SERVICE LETTER

No.⁵⁶⁶

Piper Aircraft Corporation

<u>Subject:</u>	AutoPilot Servo Spacer Bushing Installation
<u>Models and Serial Numbers Affected:</u>	All the following aircraft with a III Series Automated Flight Control System (and AutoFlite, re Cherokee models) Installation:
<u>Models Affected:</u>	<u>Serial Numbers Affected:</u>
PA-23-250 (Six Place) and PA-E23-250 (Six Place) Aztec;	27-3837, 27-3944 to 27-4467 incl., 27-4469 to 27-4488 incl., 27-4490 to 27-4514 incl., 27-4516 to 27-4527 incl., 27-4530 to 27-4535 incl., 27-4537 to 27-4547 incl., 27-4549, 27-4551, 27-4552, 27-4554 to 27-4561 incl.
PA-24-260 Comanche;	24-4783, 24-4804 to 24-4948 incl., 24-4950.
PA-28-140/180/235 Cherokee;	(140) 28-24689 to 28-26946 incl. (180) 28-5058 to 28-5859 incl. (235) 28-11078 to 28-11378 incl.
PA-28R-180/200 Cherokee Arrow;	(180) 28R-30881 to 28R-31270 incl. (200) 28R-35001 to 28R-35820 incl.
PA-30 Twin Comanche;	30-1717, 30-1745 to 30-2000 incl.
PA-31 and PA-31-300 Navajo;	31-256 to 31-536 incl., 31-538 to 31-611 incl., 31-613 to 31-639 incl., 31-641 to 31-649 incl., 31-651 to 31-661 incl., 31-663 to 31-670 incl., 31-672 to 31-675 incl., 31-677 to 31-685 incl., 31-687, 31-689, 31-691 a

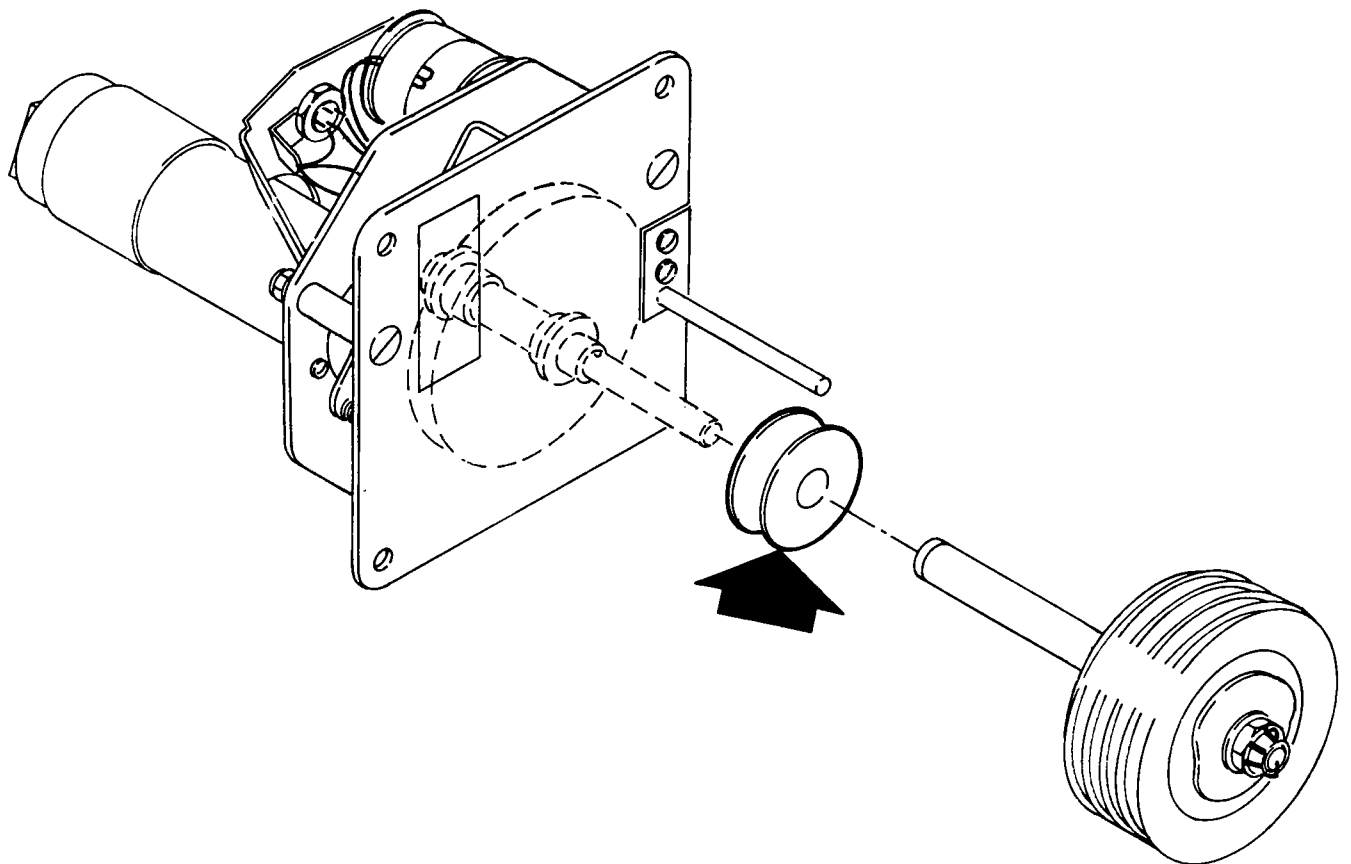
Purpose: To provide material and instructions for the installation of a spacer bushing to fill the space between the servo capstan and frame (reference attached sketch for an illustrated description).

Instructions: Contained in III Series AutoPilot Servo Spacer Bushing Installation Kit Nos. 760 472, 760 473 and 760 508V (reference Material Required, below).

NOTE: One each Servo Spacer Bushing Installation Kit will modify one servo; therefore, aircraft with a III Series AutoPilot (i.e., two servos per aircraft) will require two each of the appropriate servo spacer bushing installation kits.
